NOTICE OF VIOLATION AND COMPLIANCE EVALUATION INSPECTION, PACIFIC COAST SPROUT FARMS, SACRAMENTO COUNTY

INSPECTION REPORT

DISCHARGER: Pacific Coast Sprout Farms, Inc.

Figure 2: New influent flow meter totalizer. 8/31/2010. AMH.

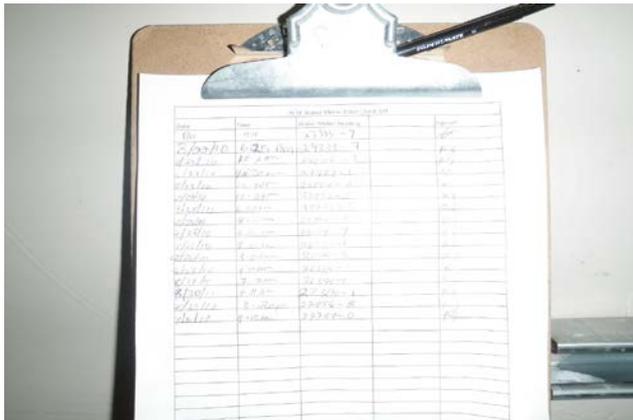
2. The Discharger is currently reporting effluent flows using a recently-installed new totalizer flow meter (figure 2). The Discharger maintains a flow meter checklist to maintain daily records of the totalizer readout (figure 3). The new flow meter was calibrated upon installation, approximately June 2010. The old influent flow meter is still in place, but not being used for NPDES compliance purposes (figure 1).

Figure 13: Pump located at the final drain in production area. 8/31/2010. AMH.

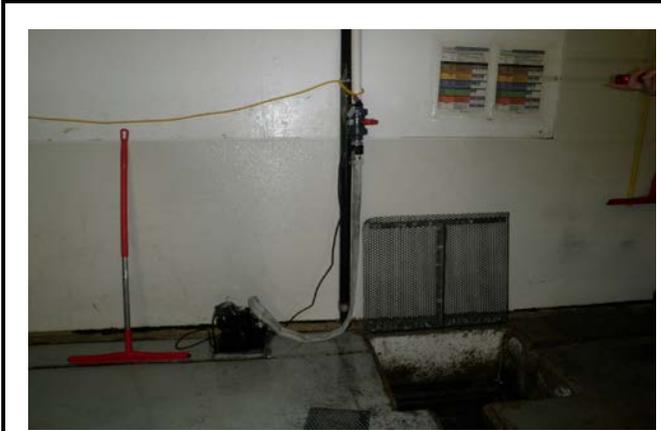
6. The production area contained a large, white basin where bean sprouts are washed and then prepared for distribution. Figures 8 through 11 show the washing basin and the long, screened channel that collects all the wastewater and conveys it to the drain located at the end of the room shown in figures 12 and 13. Mr. Scholl stated that when they use cleaning agents to sanitize the production room, they block-off the drain channel and pump the cleaning wastewater directly to the sewer system. The pump is located next to the drain, as shown in figures 13 and 14.
